Section 4(f) DeMinimis Evaluation

US 6 / IL 7 / 159th Street
(Will-Cook Road to Ravinia)

IDOT Job No. P-91-284-93

RE: IDOT 159th Street Widening – Ravinia Avenue to Gougar Road
IDOT Job No. P-91-284-93
Letter of Intent

ATTACHMENT 03 - PROPOSED ROADWAY 1 of 2
159TH STREET PLAN & PROFILE
SCALE: 1"=50' SHEET 48 OF 551 SHEETS STA. 365+00.00 TO STA. 380+00.00

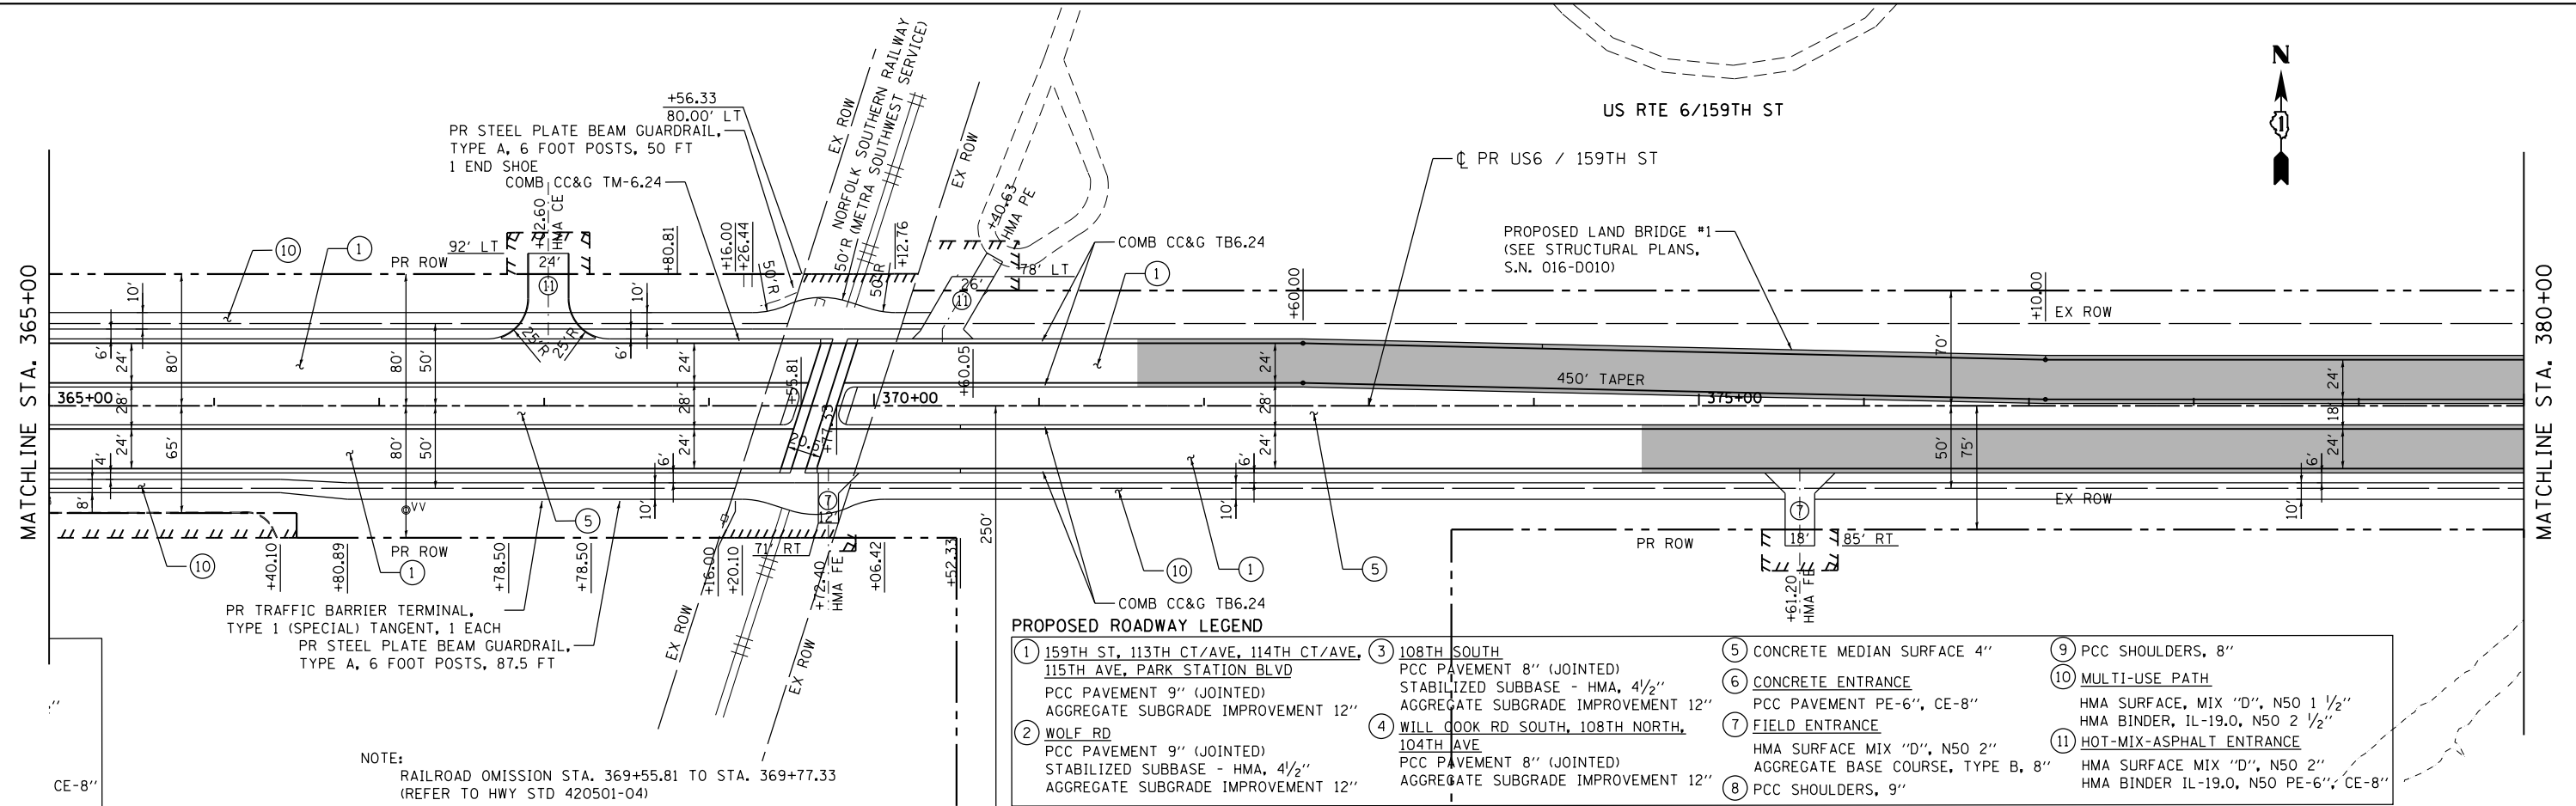
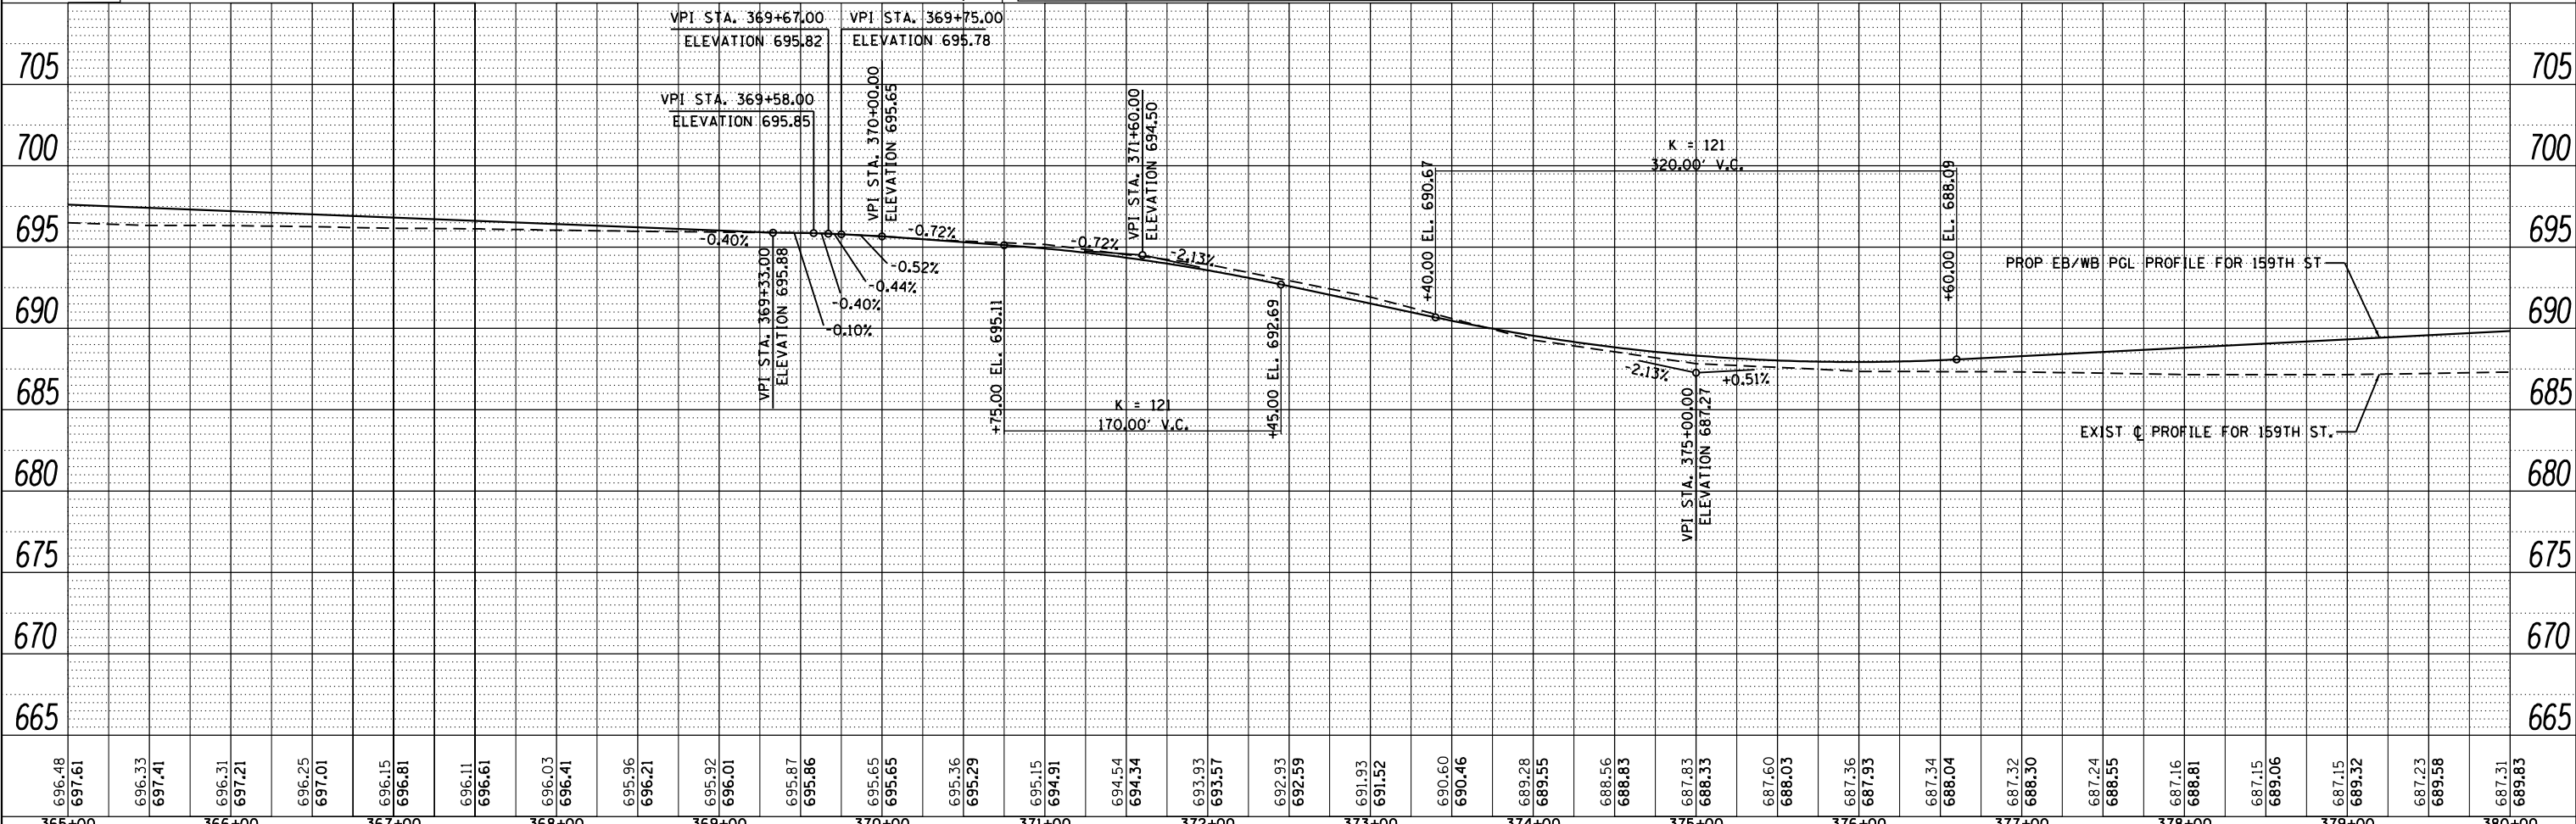
- a. The proposed improvements include providing additional shared-use path access to the park at 104th Avenue. The regional shared-use path to be constructed along the 159th Street corridor will be connected to the internal walking / bike path in the park. The improvements will also include additional right-of-way to provide a natural buffer between the roadway and the park. The overall impact will be 0.146 acre of temporary easement for construction of the path connections and 0.52 acres of permanent right-of-way for a natural buffer between the roadway and park.
- b. The anticipated impact to the Park property is limited to the removal of several trees as necessary to construct a drainage ditch and the shared-use path connections. Tree replacement will follow IDOT policy. The improvement will provide additional access to

- a. The proposed median width along 159th Street has been reduced from Sta. 372+60 to Sta. 413+50 to minimize the roadway width from 28 feet wide to 18 feet wide. The path connection is intended to enhance public access to the park. The additional right-of-way will allow for a natural buffer area between the park and the roadway by allowing for graded slopes. Without the right-of-way, retaining walls are required and vary in height from 1 foot to 8 feet high adjacent to the existing park internal path. Trees replacement will follow IDOT policy.
- b. List of Commitments for Mitigation or Enhancement: None.
